1968 Corvette: Service News: Corvette Folding Top Compartment Lid to Folding Top Interference (SN-68-20)

Source: Chevrolet Service News

Date: April 1968, Volume 40, Issue Number 4

Fig. 12—Remove $\frac{1}{8}$ " From Lid Stops

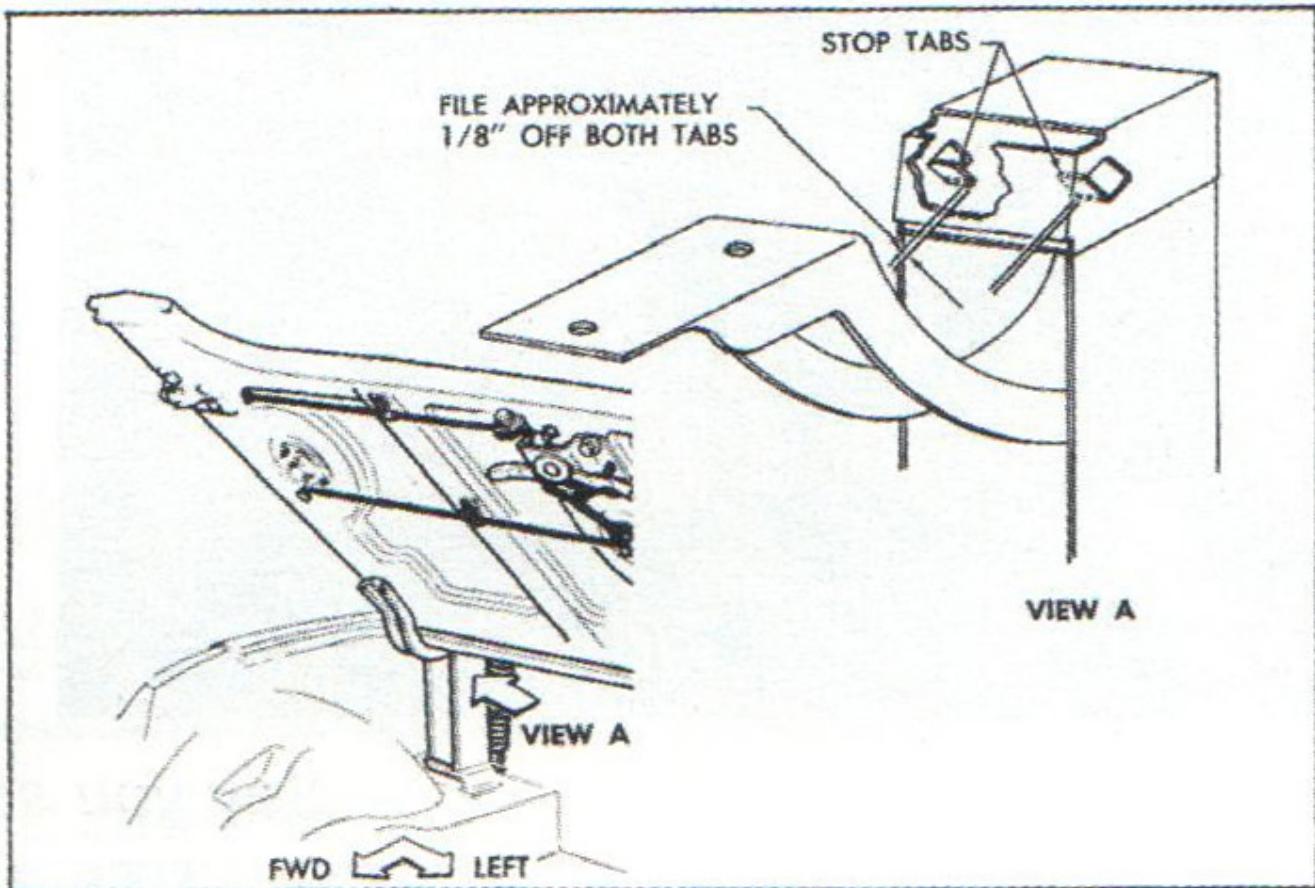
It has been found that the rear compartment lid on some 1968 Corvettes interferes with the convertible top when the top is being raised or lowered. This interference is easily eliminated by filing approximately 1/8" off the existing hinge stops (right and left side). Removing 1/8" from the hinge stops, as shown in Figure 12, allows the rear compartment lid to raise farther thus eliminating the interference condition. The stops referred to are simply tabs that has been punched out of the hinge support members.
